STANDARDS & SPECIFICATIONS SITE INSPECTION REPORT LEVEL 1 (FIELD REPORT)

| Project Name: | Mountain Valley Pipeline | S&S Program: | Mountain Valley Pipeline (SS027) |
| Spread I: Franklin County Pittsylvania County | MVP-MLV-AR-32 MVP-MLV-AR-33 MVP-MLV-AR-34 STA 14223+00 – 14249+00 | Site Conditions: | Rainy |

Fig. 2

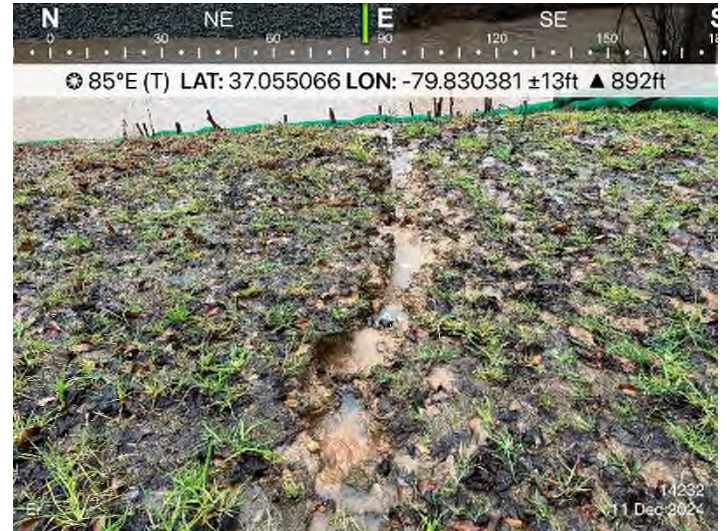
STA 14232+00: Erosion occurring above S-C19.

- STA 14232+00: CFS cleanout/maintenance (24-hr)
- STA 14232+00: Repair and restabilize area (72-hr)
- STA 14231+00: Repair perm. WB (72-hr)

Fig. 3

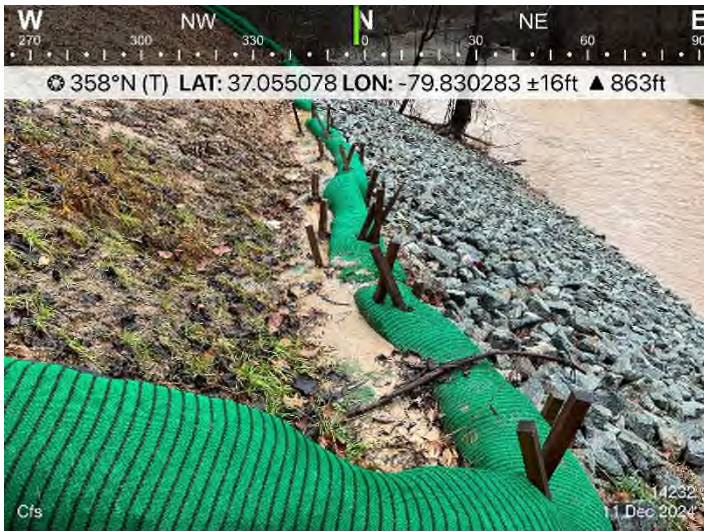
STA 14232+00: CFS full above S-C19.
